# SERVICE BULLETIN

No. 203

**SUBJECT:** Modification of Cabin Heat Box Plate

**MODELS AFFECTED:** PA-22-108 Colt Aircraft - Serials 22-8000 to 22-8440 inclusive and 22-8443

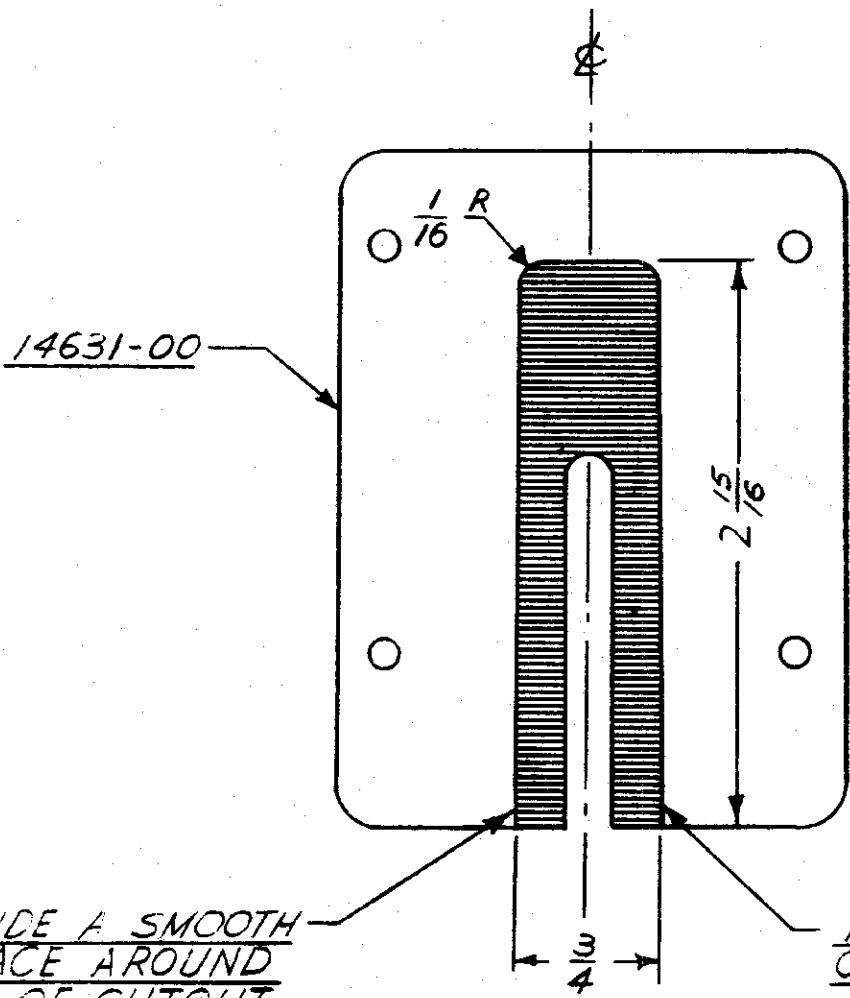
The cabin heat box plate part number 14631, interferes with the movement of the safety belt attaching link. This restriction of movement prevents the safety belt loop from contacting the entire bearing surface of the link when the safety belt is in use.

It is requested that the cabin heat box plate be modified in accordance with the sketch of the reverse side on this bulletin.

PROVIDE A SMOOTH SURFACE AROUND EDGE OF CUTOUT TO AVOID ABRASION OF SEAT BELT.

TRIM MATERIAL CUT OF AREA INDICATED
